SUBDIVISION REVIEW SHEET**CASE NO.:** C8-2023-0149.1A**COMMISSION DATE:** October 17, 2023**SUBDIVISION NAME:** Eastside Commerce Subdivision**ADDRESS:** 1312 Dalton Ln**APPLICANT:** David M. Blackbird (SRPF C/Dalton Lane, LP)**AGENT:** Thomas Lombardi, Jr. (Kimley-Horn)**ZONING:** CH-CO, CS-CO, LI**NEIGHBORHOOD PLAN:** N/A**AREA:** 59.859 acres**LOTS:** 12**COUNTY:** Travis**DISTRICT:** 3**WATERSHED:** Carson Creek**JURISDICTION:** Full Purpose**SIDEWALKS:** Sidewalks will be constructed along Dalton Ln and SH-71.**DEPARTMENT COMMENTS:**

FINAL PLAT EASTSIDE COMMERCE SUBDIVISION

CITY OF AUSTIN –DEVELOPMENT SERVICES DEPARTMENT
SUBDIVISION APPLICATION – MASTER COMMENT REPORT

PROJECT NAME: Eastside Commerce Subdivision
LOCATION: 1312 DALTON LN

SCALE	DRAWN BY	CHECKED BY	DATE	PROJECT NO.	SHEET NO.
1" = 100'	TJR	MMII	9/18/2023	068213106	1 OF 4

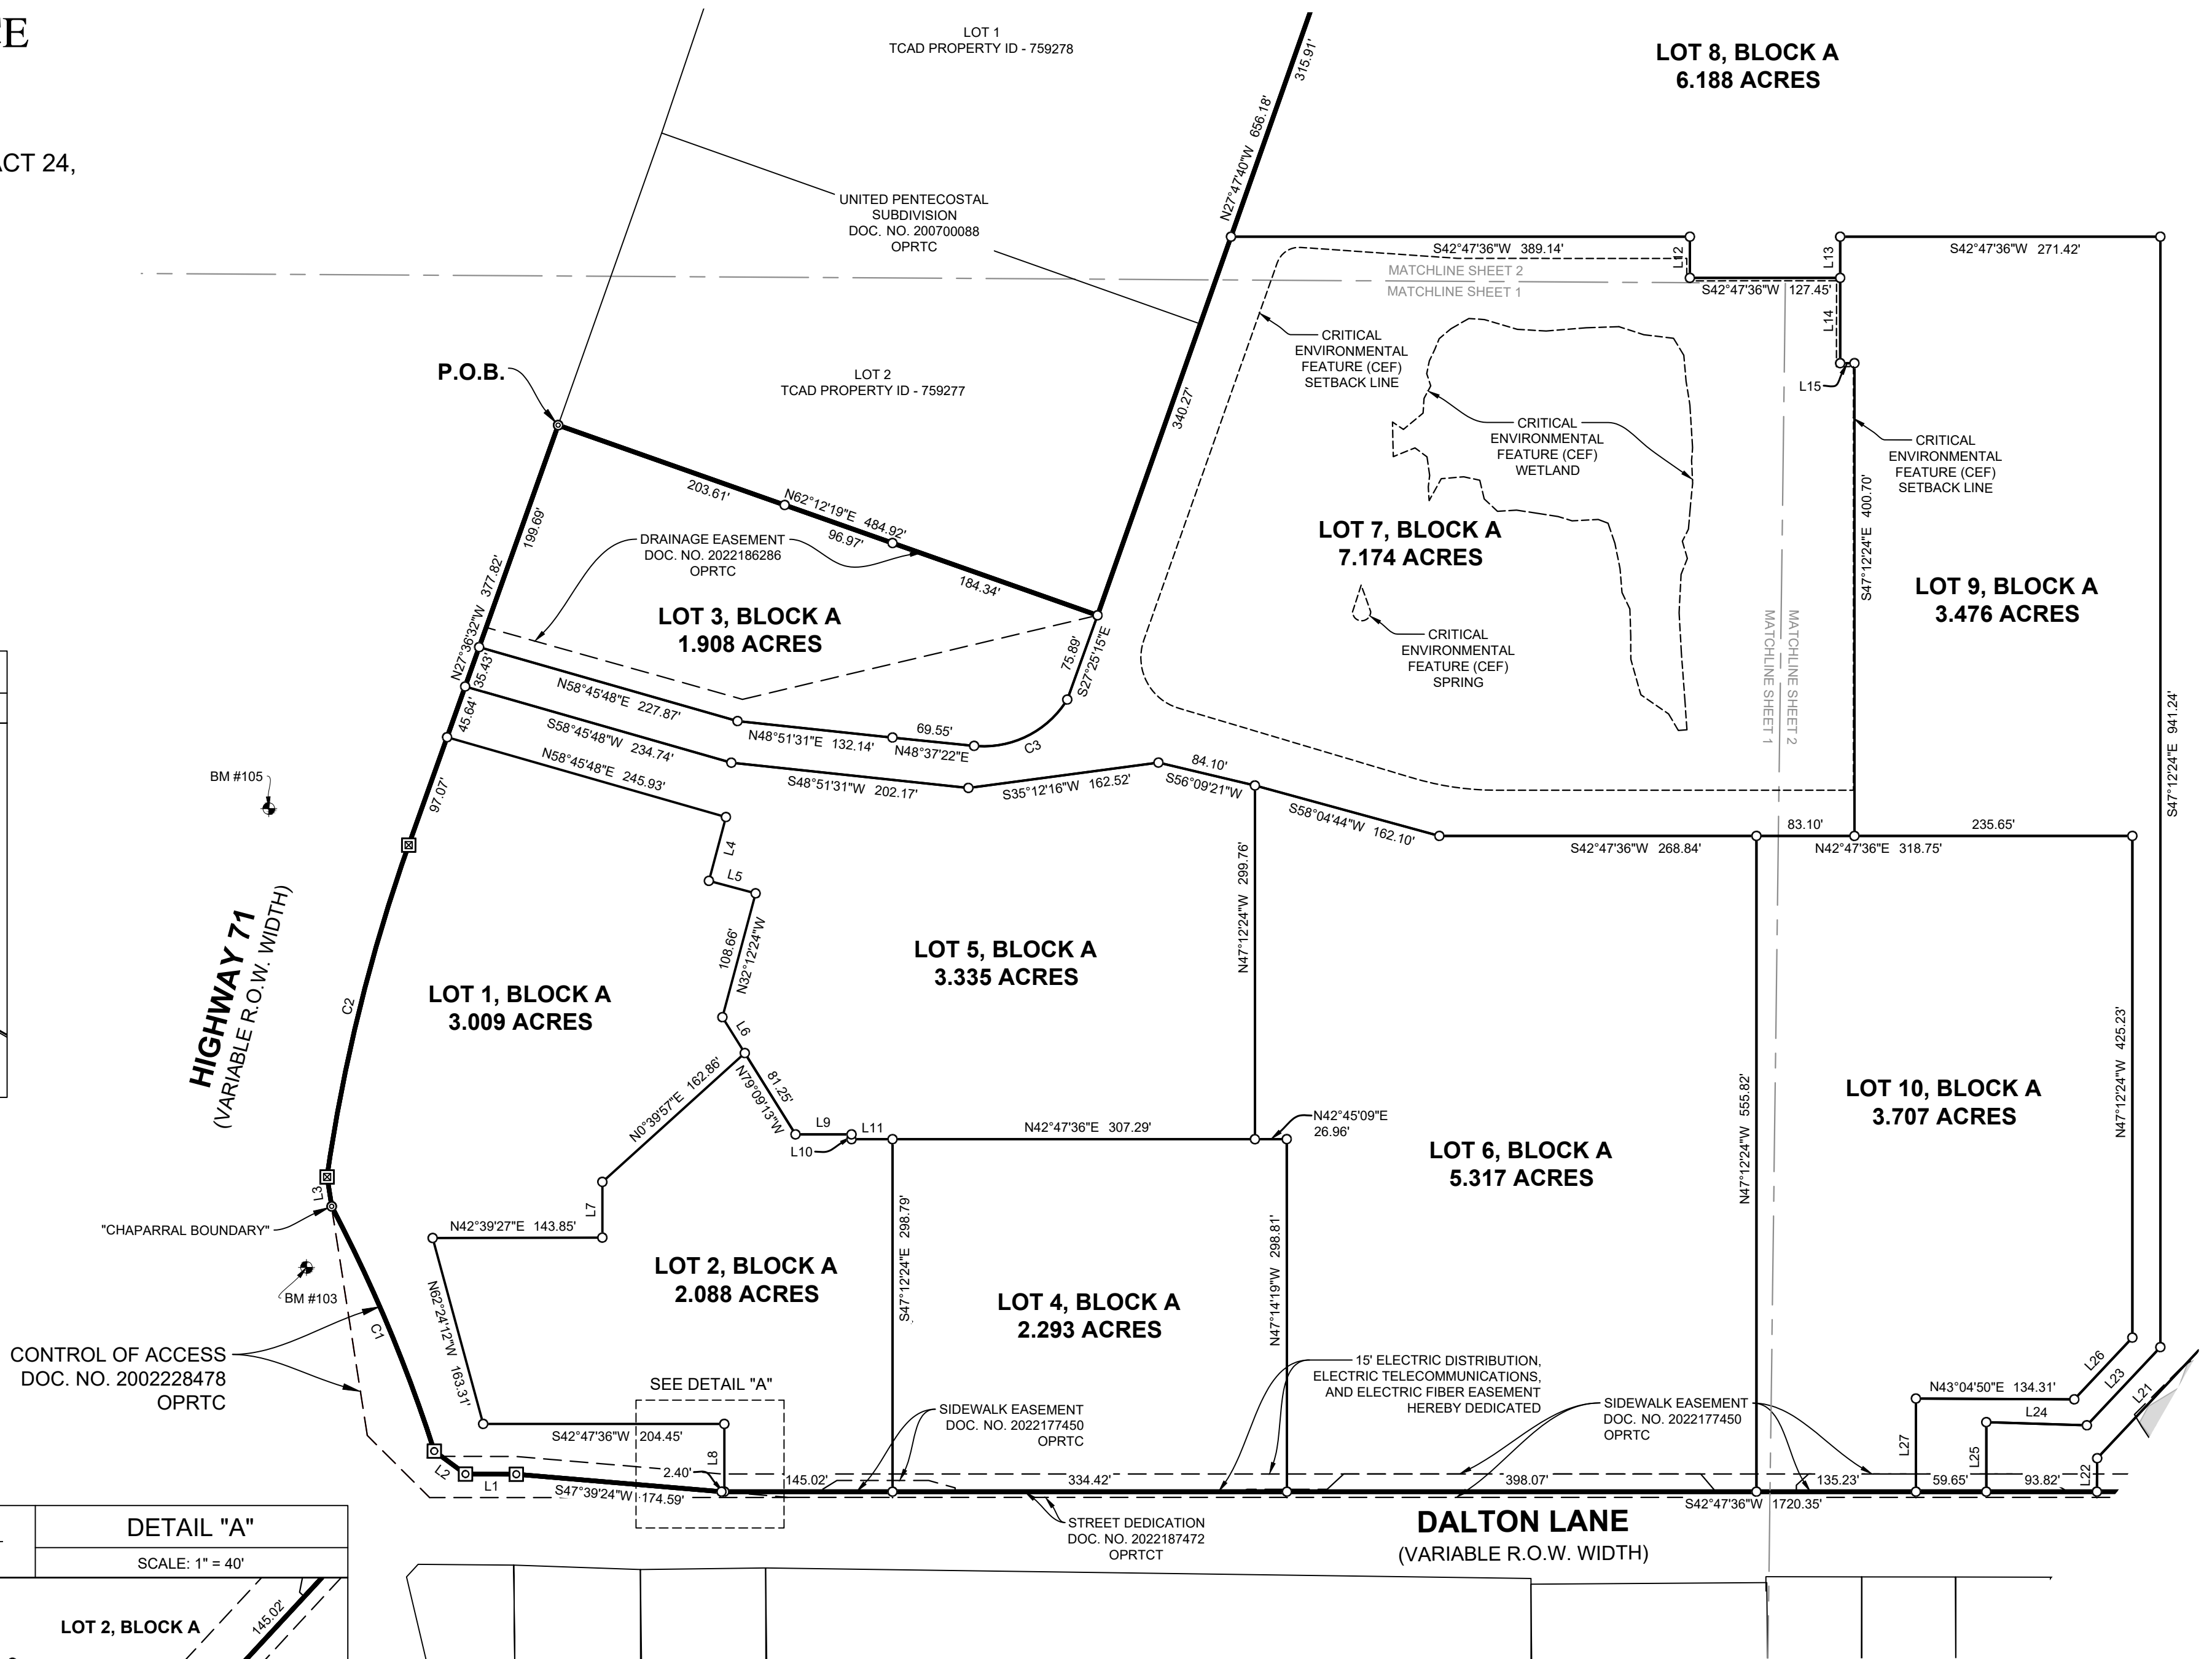
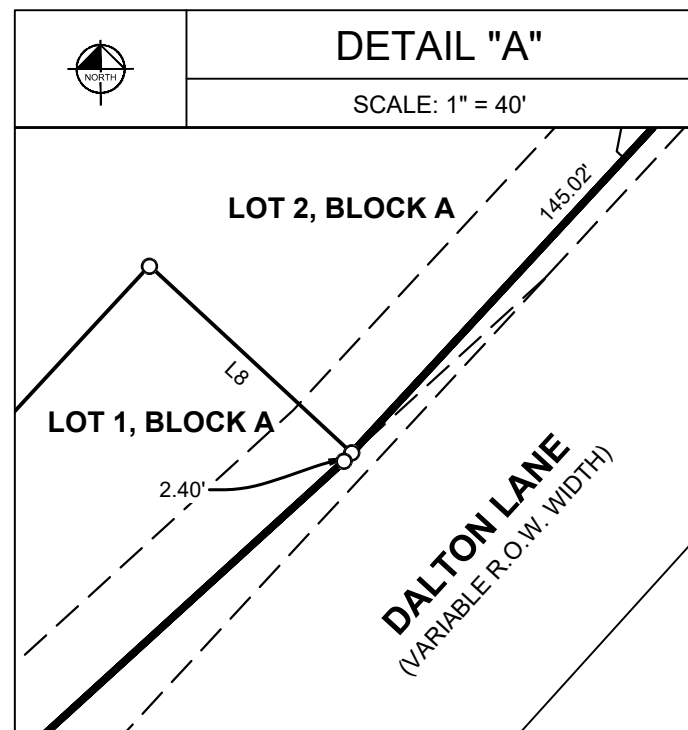
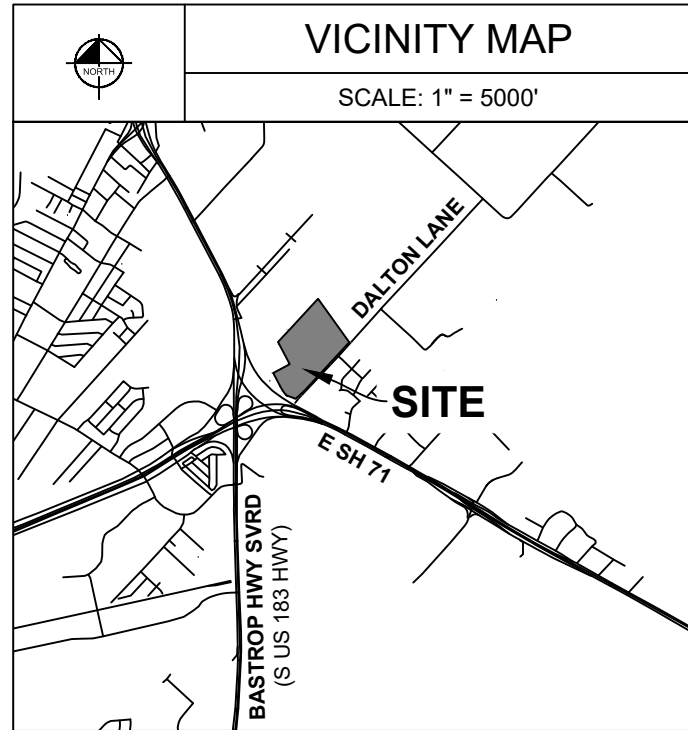
Fifty-foot electric transmission, electric distribution, electric telecommunications, and electric fiber easement is required adjacent to Highway 71 ROW to cover existing electric facilities. Please show easement on the face of the plat.

AD3: On sheet 1 please update the label for HIGHWAY 71 to BASTROP HWY SVRD as seen here.
E SH 71 is labeled correctly on the vicinity map.

ATD 5. Please show the dotted lines along Dalton Lane and Highway 71 for the sidewalk per the legend and add Highway 71 to plat note #10.

U1: Response noted. Comment remains. Please show sidewalks For Dalton Lane and Highway 71 to clear the comment.

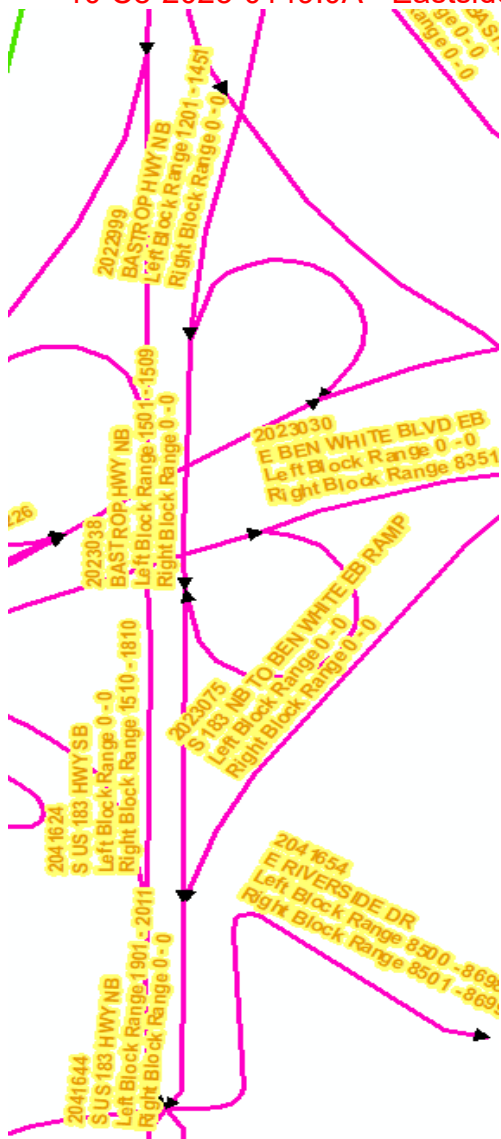
AD2: In the vicinity map please update the label for BASTROP HWY as shown in the map below
S US 183 HWY can remain in the vicinity map, but without parenthesis.
